ADDENDUM NO. 2
to
CONTRACT DOCUMENTS

for
**DOOR REPLACEMENT AT
WILDWOOD MIDDLE SCHOOL / HIGH SCHOOL**
located at 4300 Pacific Avenue, Wildwood, NJ 08260

**AND
GLENWOOD AVENUE ELEMENTARY SCHOOL**
located at 2900 New York Avenue, Wildwood, NJ 08260

Issued: December 16, 2024

Drawing Number
A601

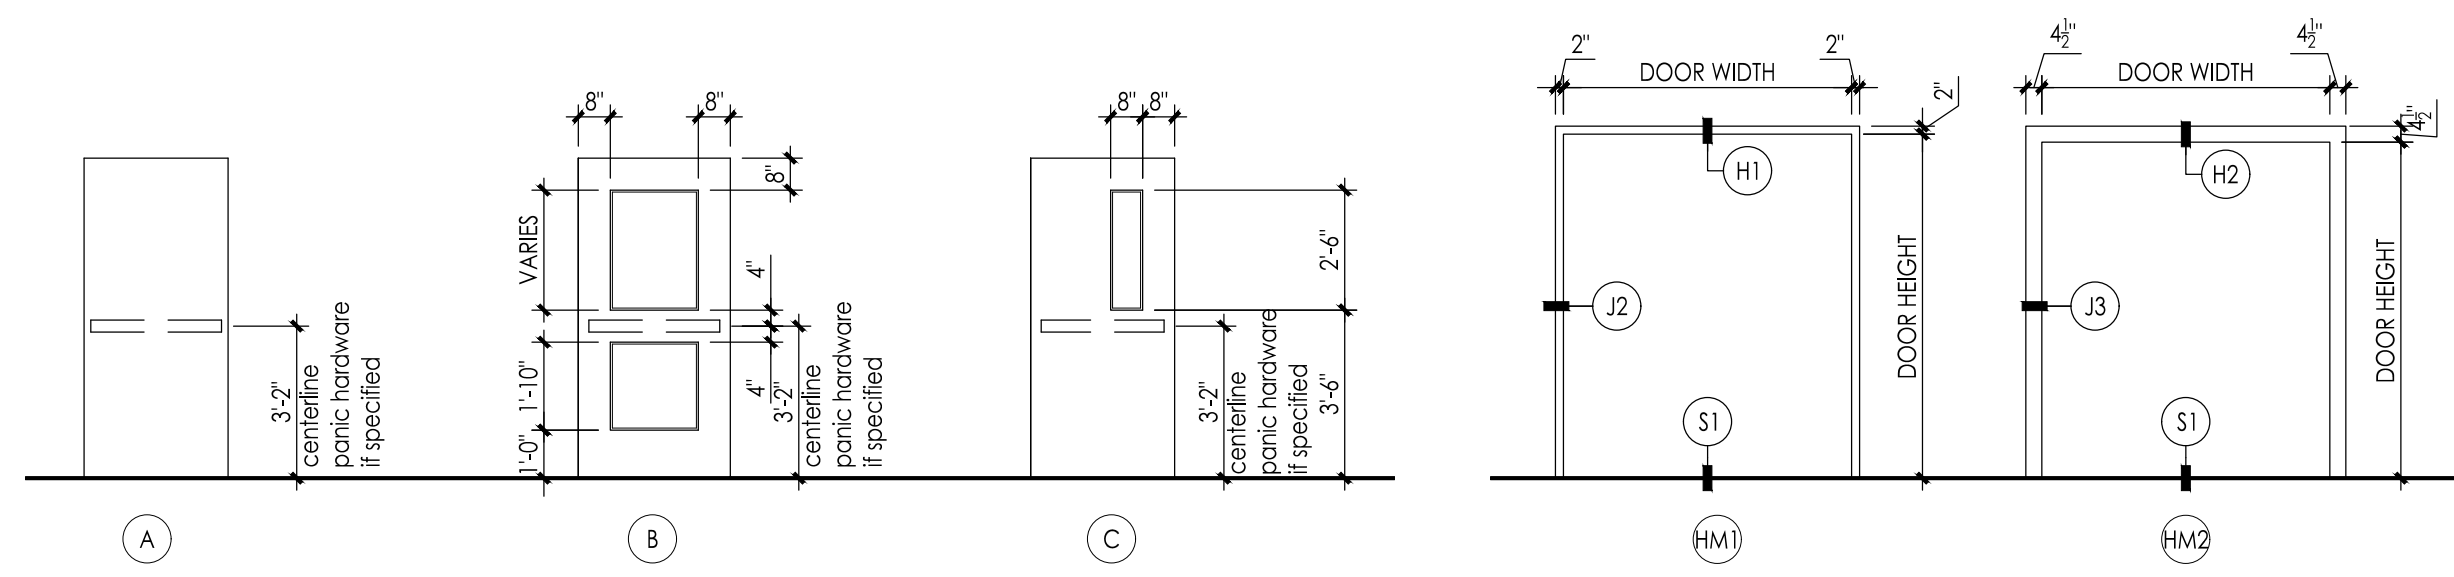
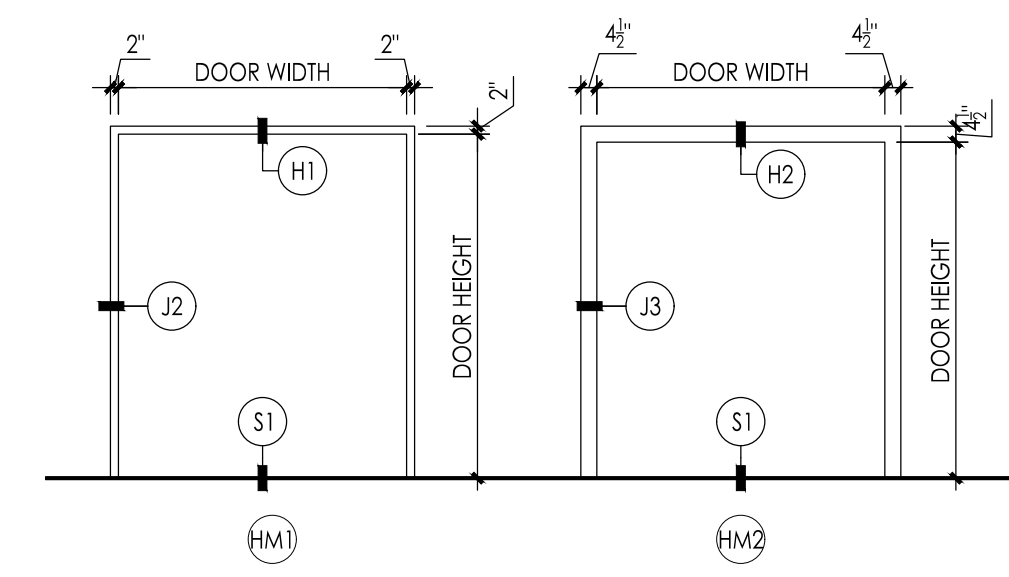
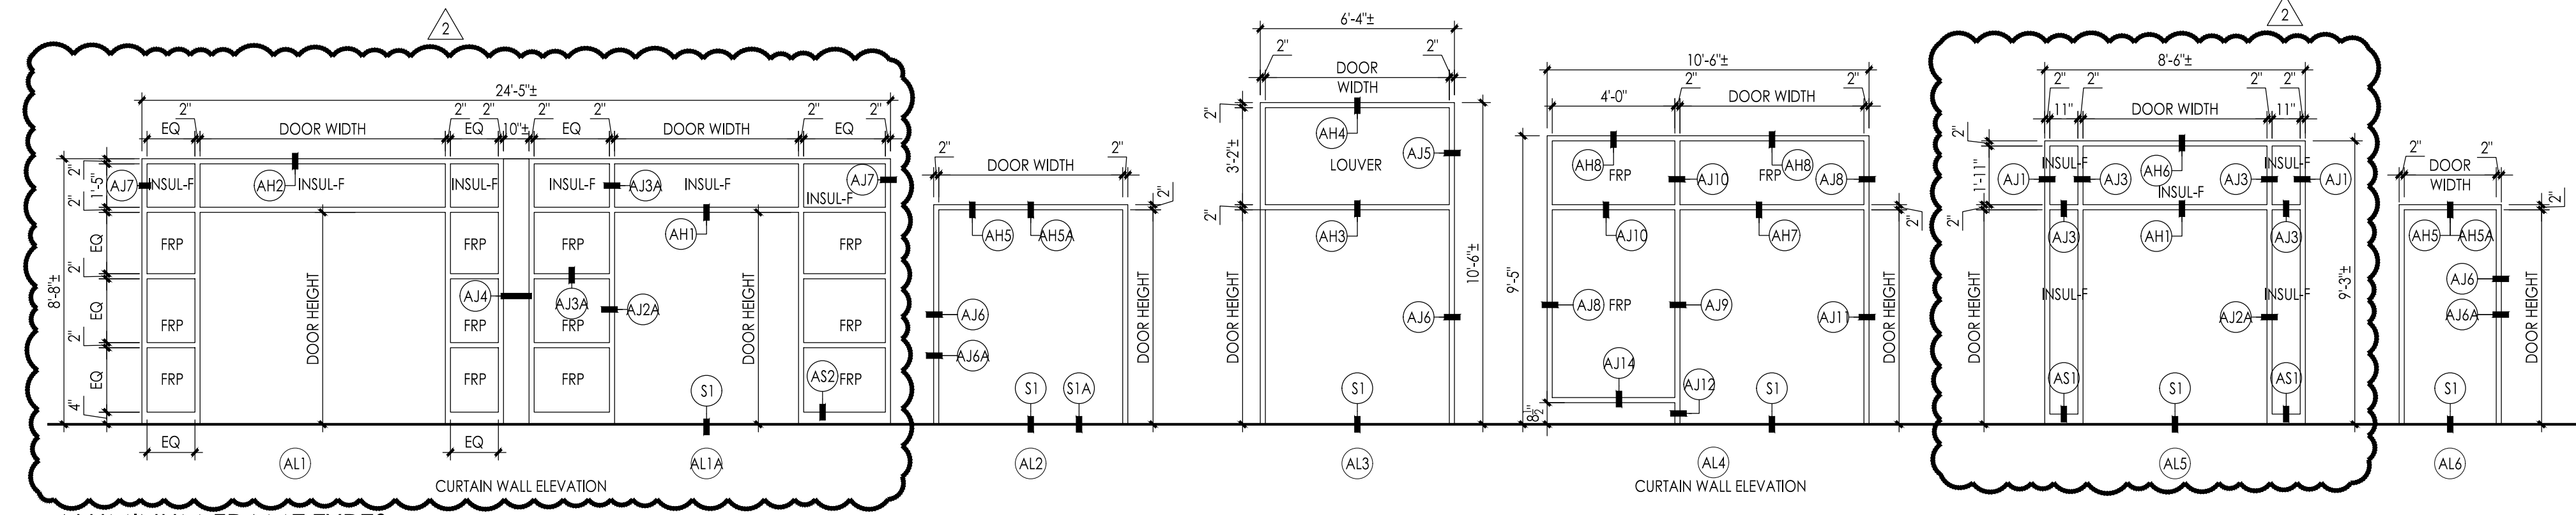
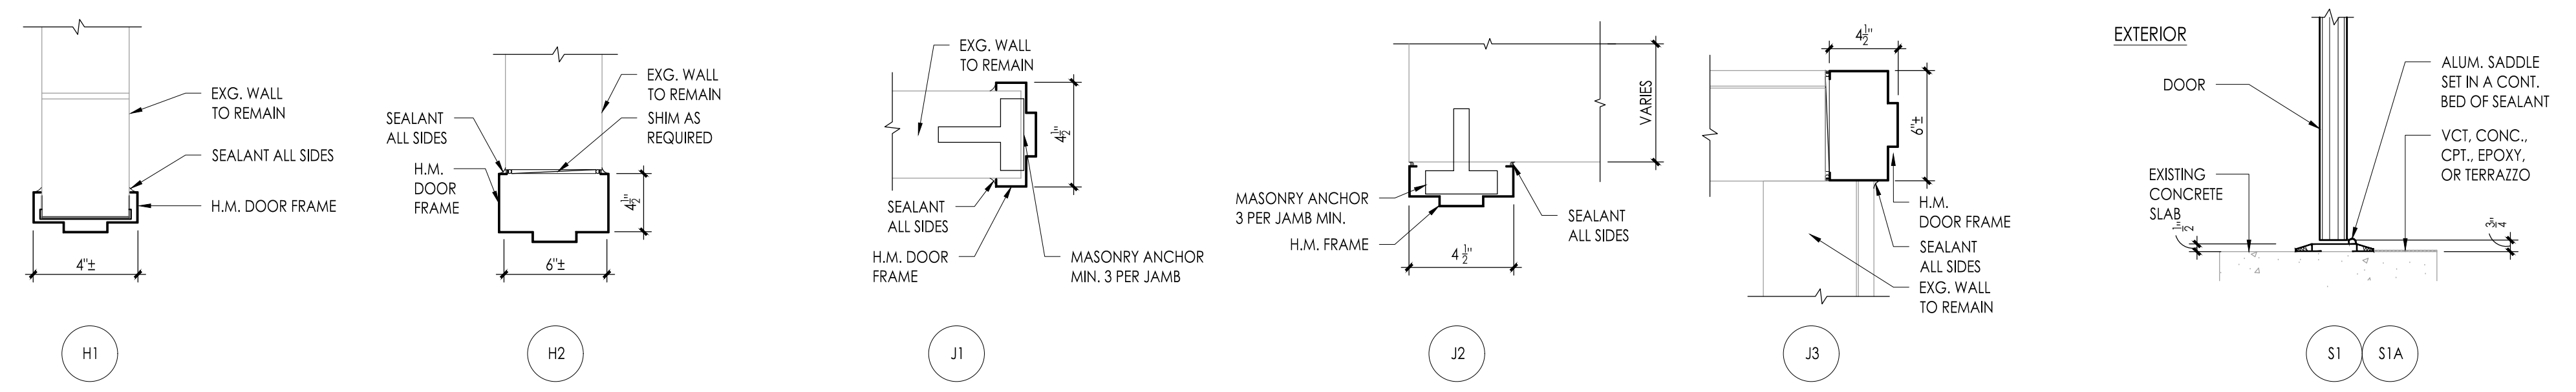
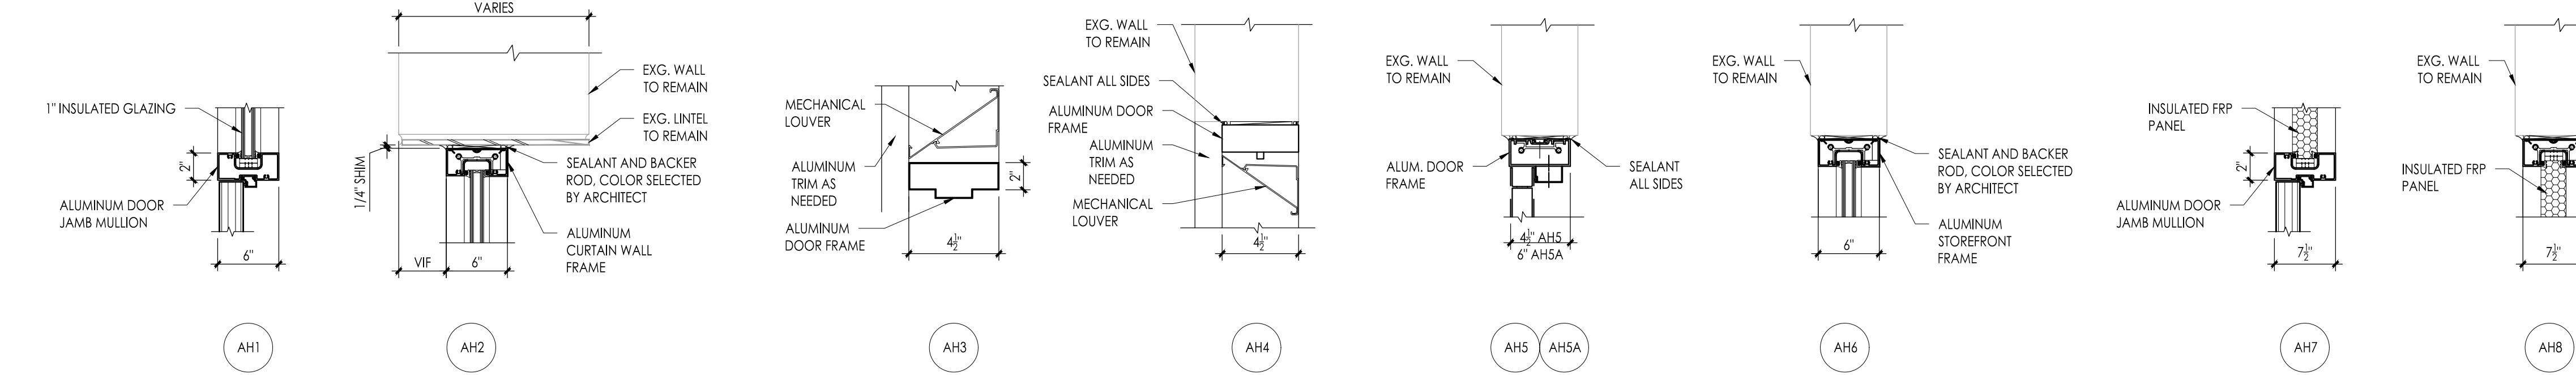
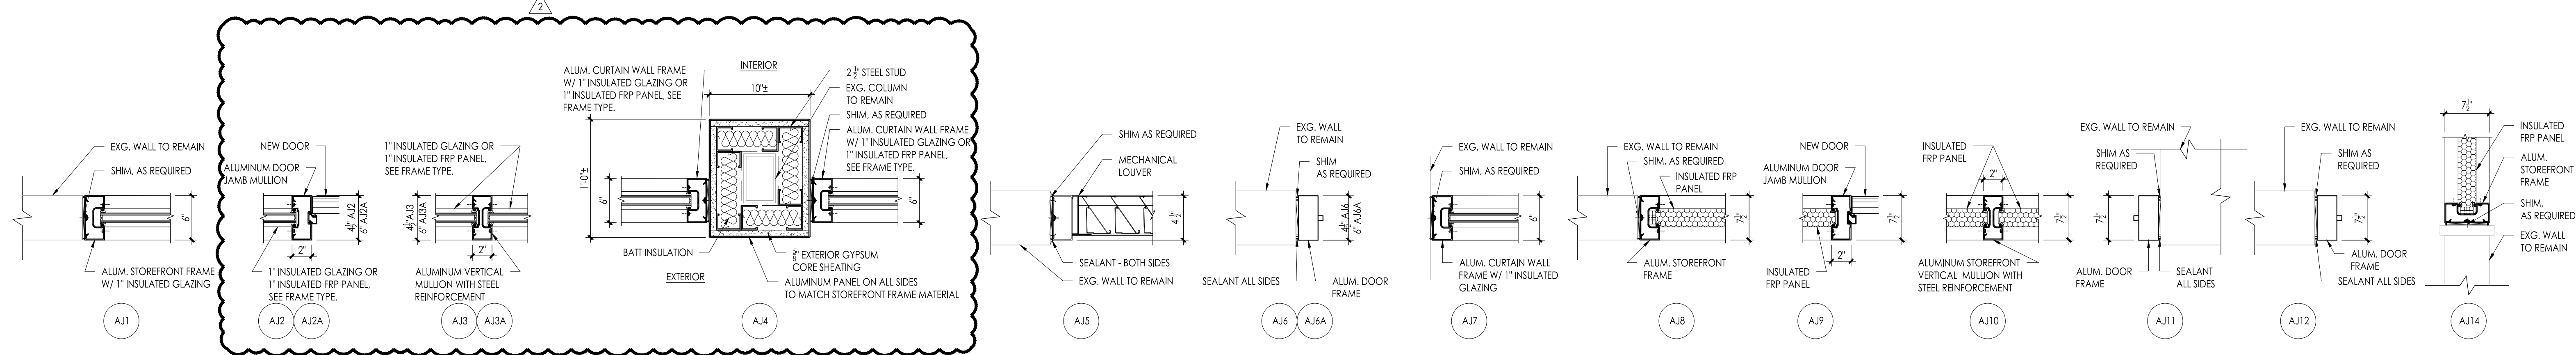
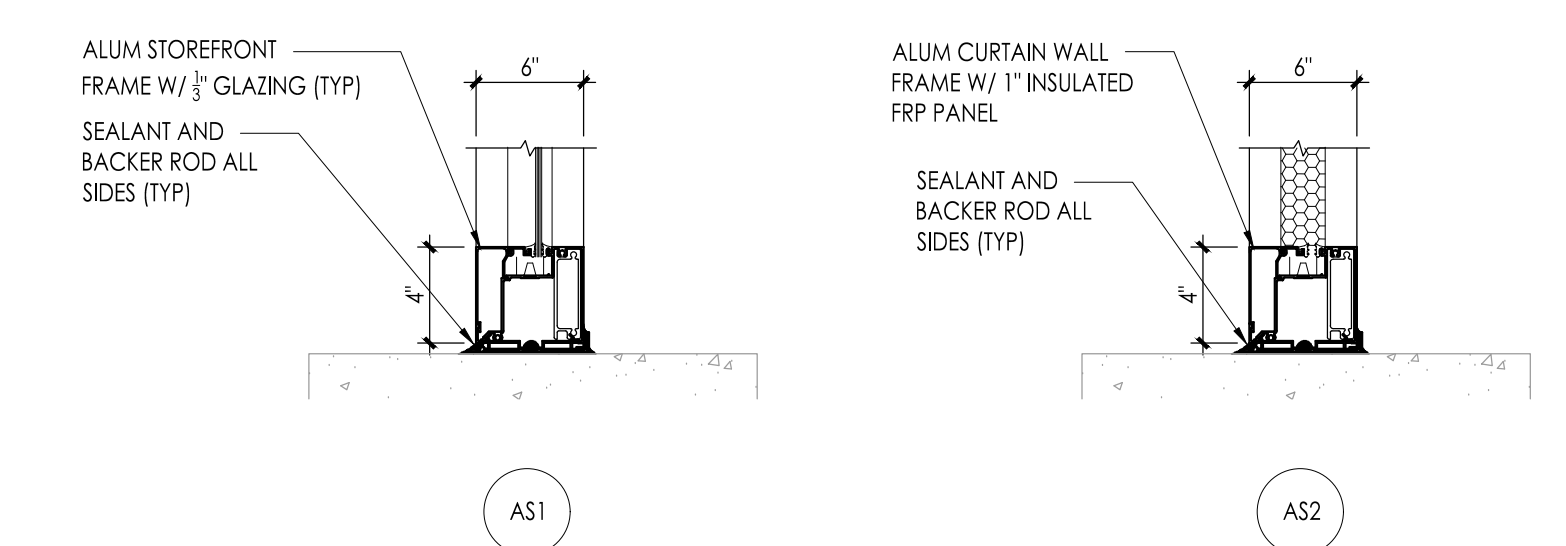
1. Question: On A601, it has door schedule notes. Note #5 calls for a security film to be applied as indicated. Looking at door schedule on same page, no door has note #5. Wanted to clarify that no door will receive security film.

2. Question: On A601, in Door Schedule Notes #6 and #8, it makes reference to the Owner providing their Security Vendor. When the successful Bidder is awarded, will Owner coordinate with Security Vendor to disconnect and reconnect as needed?

Response: Refer to revised Drawing A601 for applicable references to the security window film.

Response: Refer to revised Drawing A601, Door Schedule Notes #6.

- SECURITY FILM SHALL BE APPLIED TO INDICATED EXTERIOR DOOR VISION LITES, SIDE LITES AND TRANSOMS.
- EXISTING CARD ACCESS DEVICES SHALL REMAIN AND BE TEMPORARILY DISCONNECTED AND RE-CONNECTED TO NEW ELECTRONIC DOOR HARDWARE BY OWNERS SECURITY VENDOR. CONTRACTOR SHALL ENGAGE THE DISTRICT'S SECURITY VENDOR TO REMOVE AND REINSTALL ALL DOOR ACCESS ELECTRONICS AS NEEDED TO REPLACE DOORS.
